CITY OF ALBUQUERQUE

**RE: 13705 Winterwood SE
Grading and Drainage Plan
Engineer's Certification Date: 07/17/20
Engineer's Stamp Date: 09/18/19
Hydrology File: L23D002A**

DRAINAGE AND TRANSPORTATION INFORMATION SHEET (REV 6/2018)

ENGINEER'S SEAL	13705 WINTERWOOD	DRAWN BY WCVJ
	GRADING AND DRAINAGE PLAN	DATE 9-13-19
		2109068-LAYOUT-8-21-19
9/18/19		SHEET #
DAVID SOULE P.E. #14522		JOB # 2109074

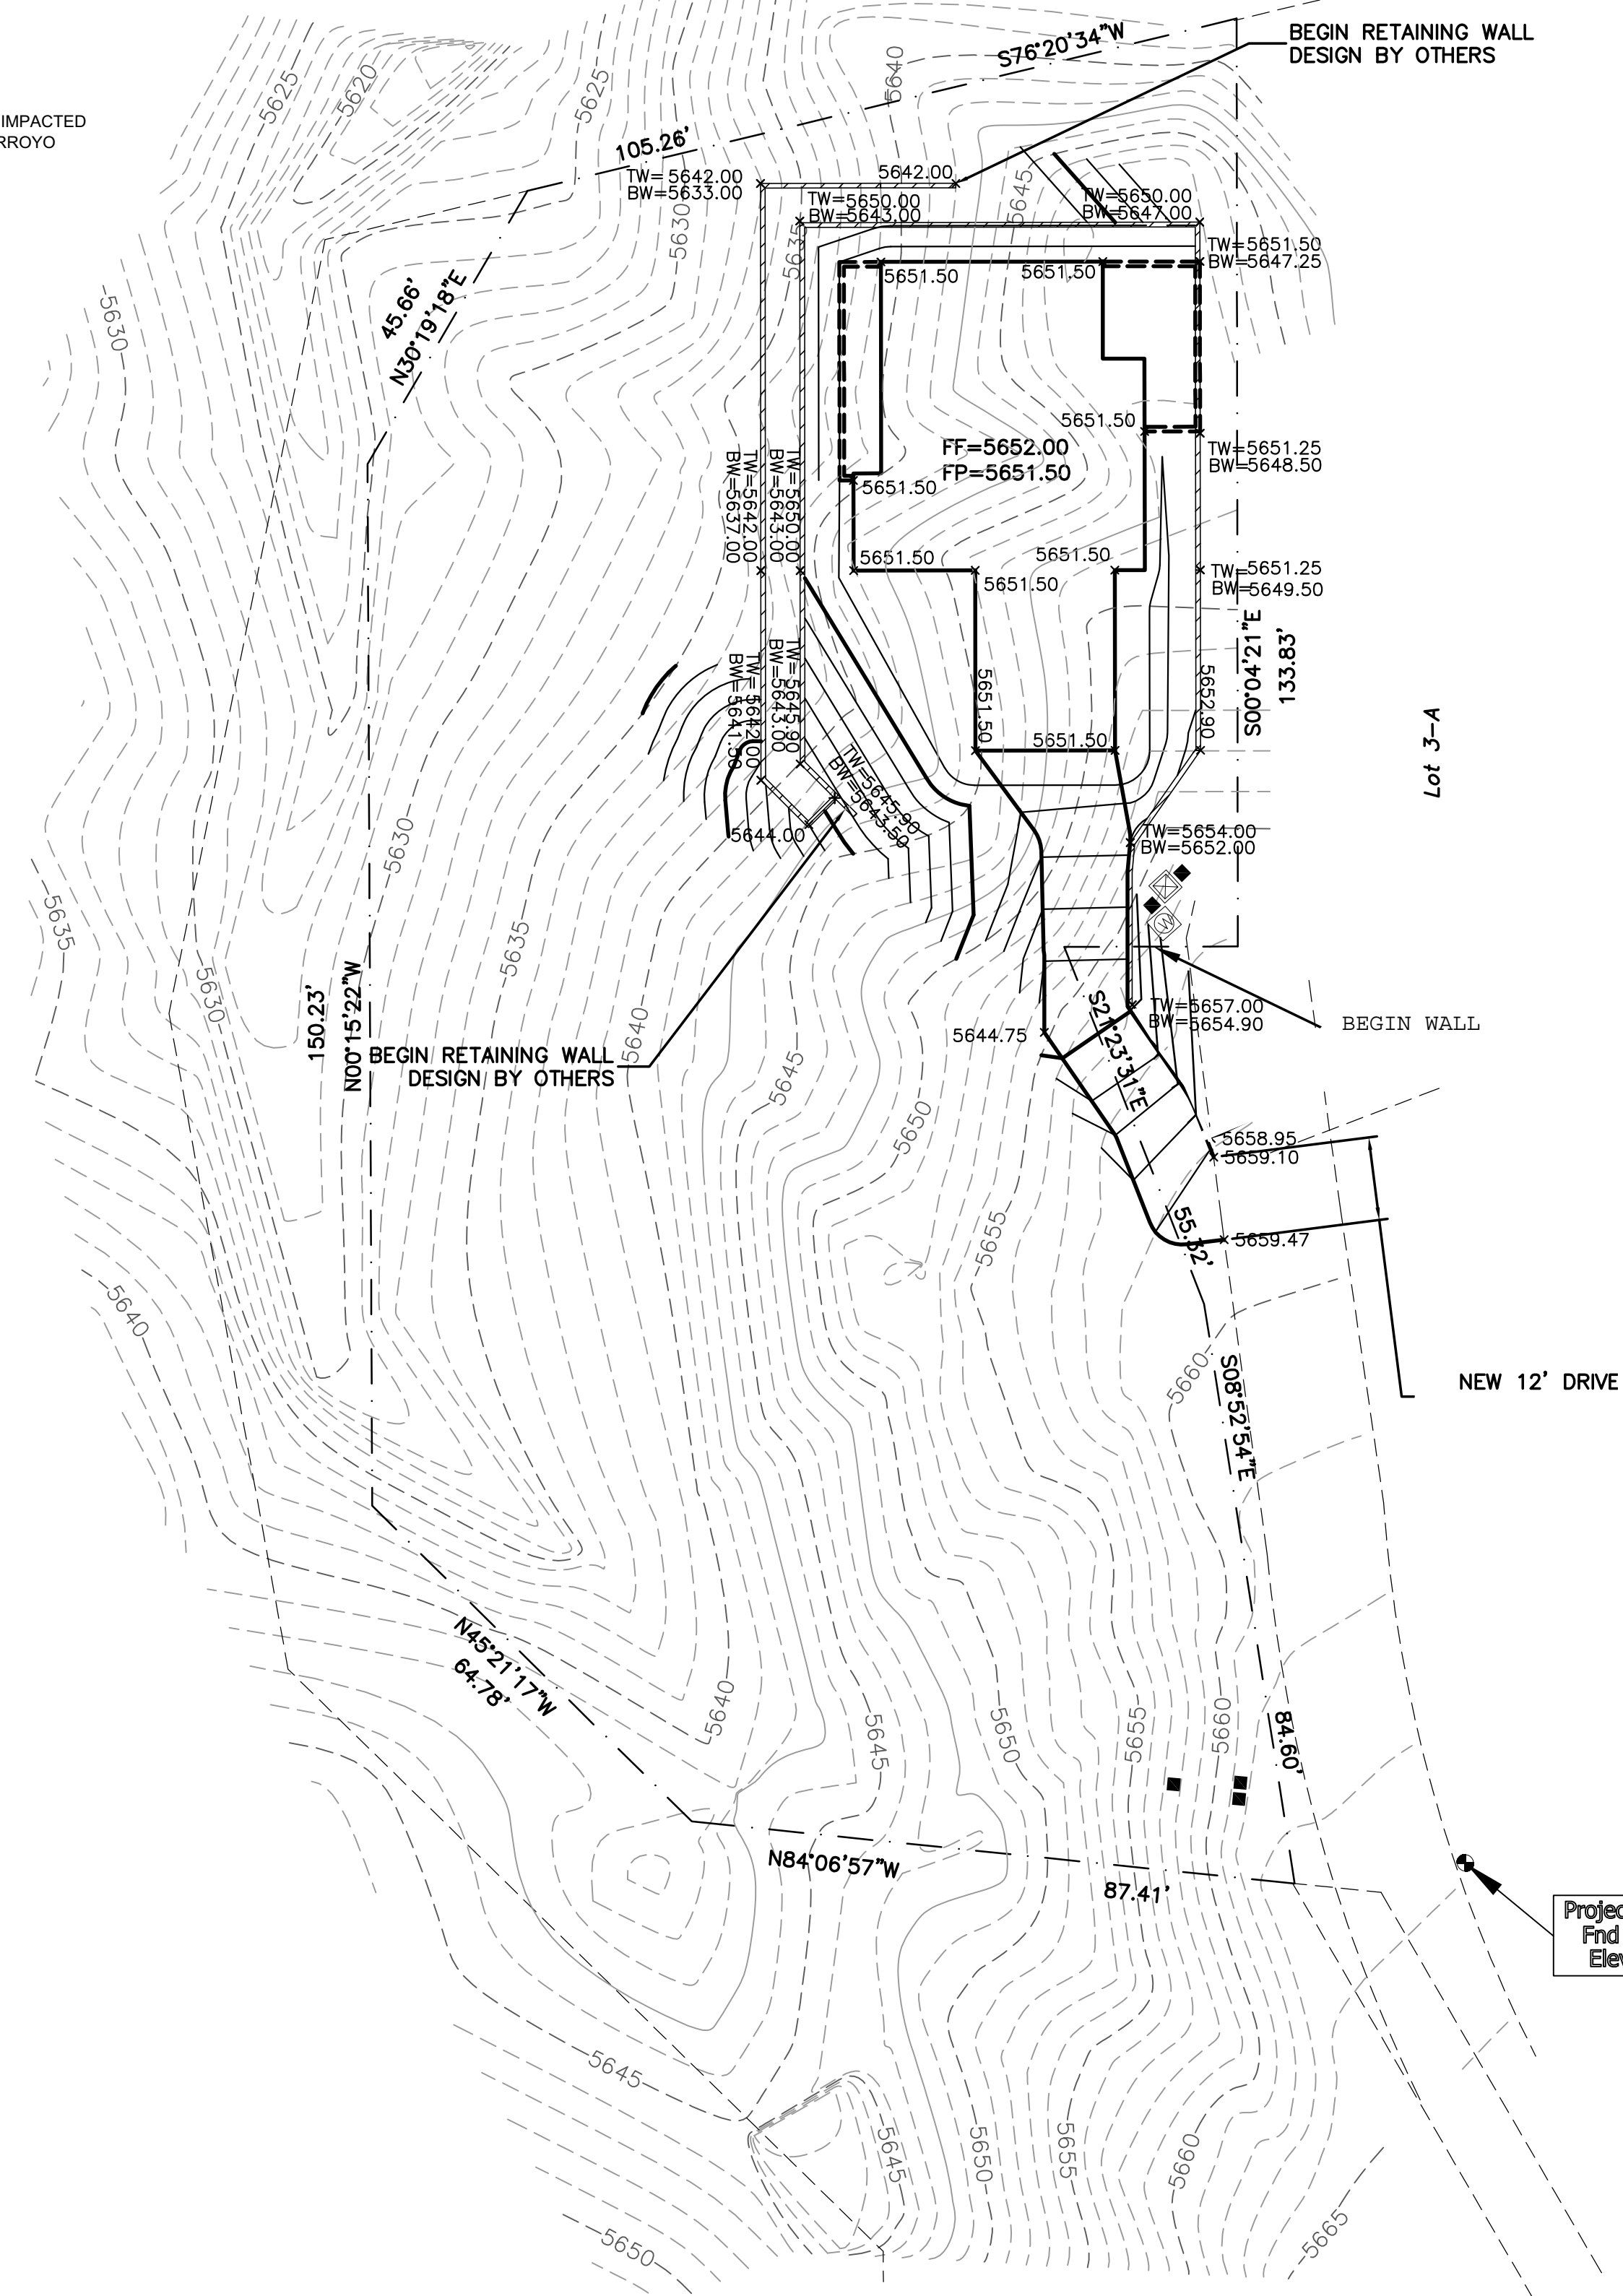
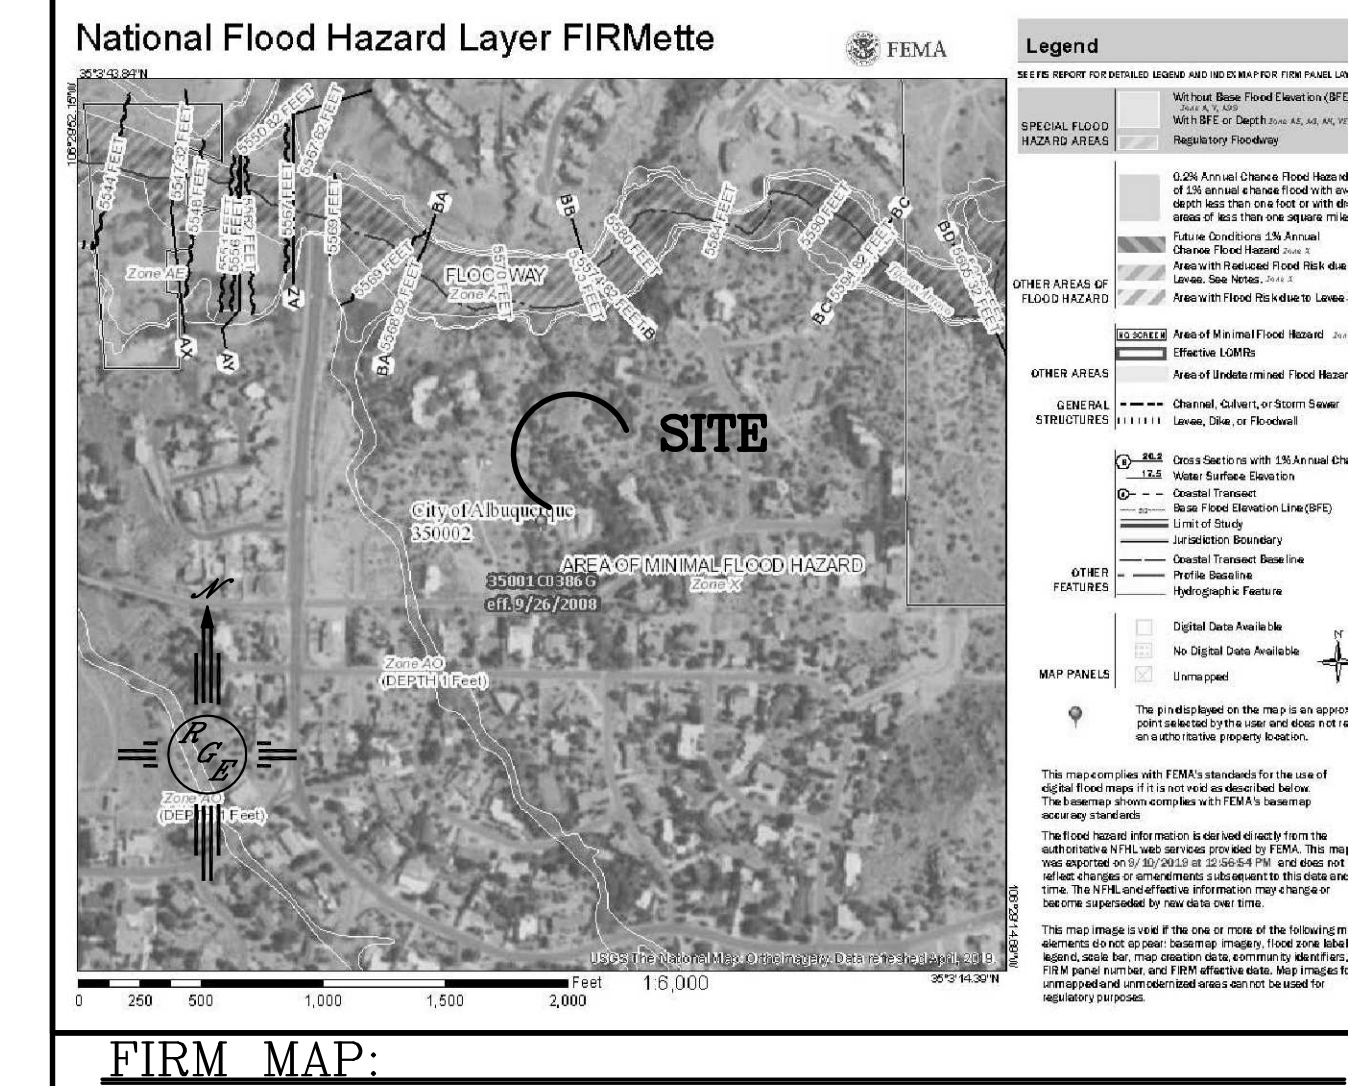
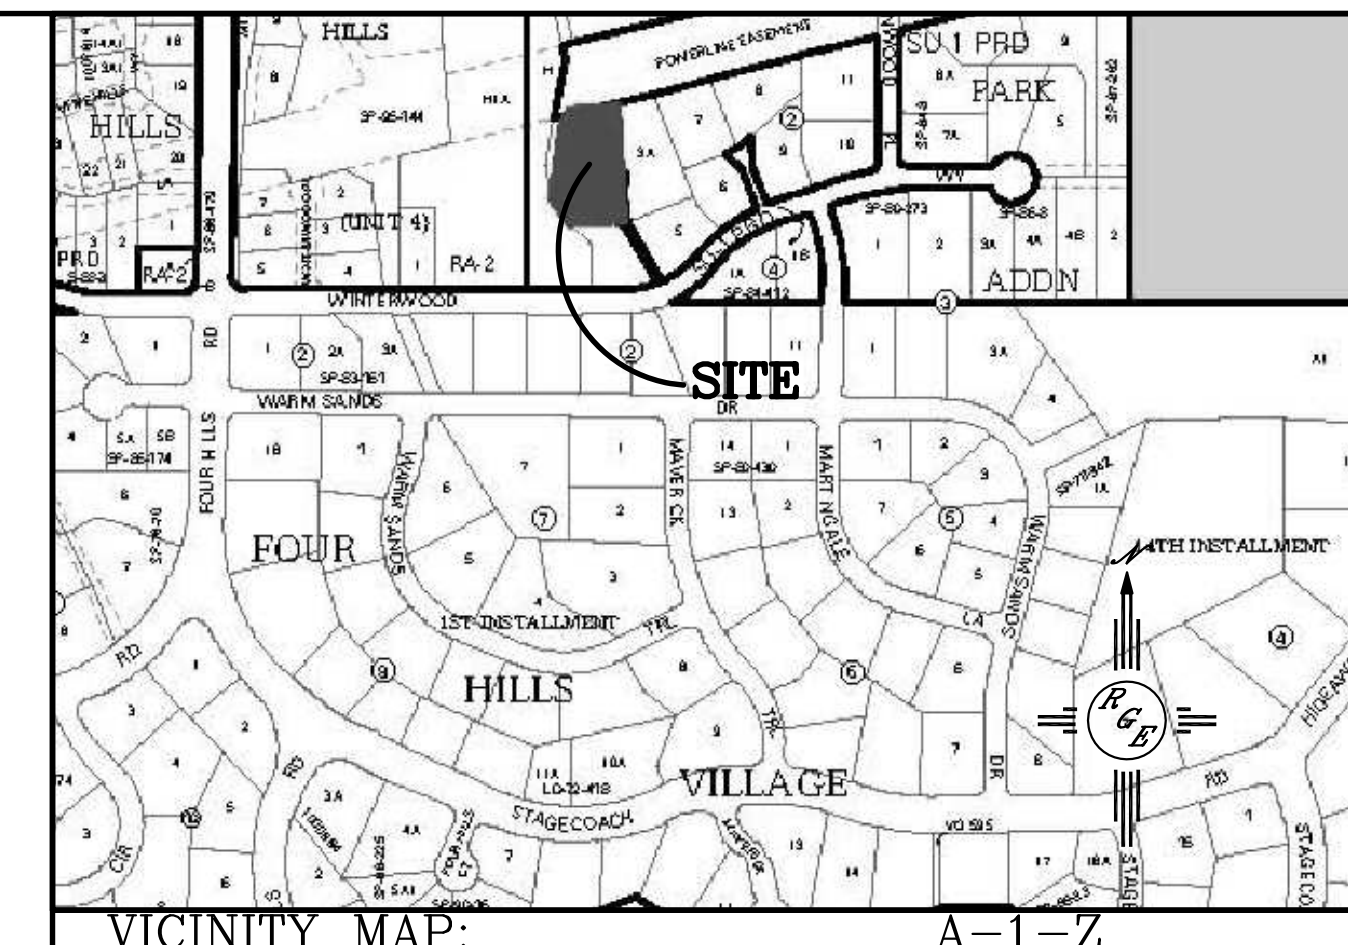
Based upon the information provided in your submittal received 08/06/2020, the Grading and Drainage Plan are approved for Building Permit and Building Pad Certification for 13705 Winterwood SE. Please attach a copy of this approved plan in the construction sets for Building Permit processing along with a copy of this letter.

Prior to approval in support of Permanent Release of Occupancy by Hydrology, Engineer Certification per the DPM checklist will be required. Also the plat needs to be recorded prior to Permanent Release of Occupancy by Hydrology.
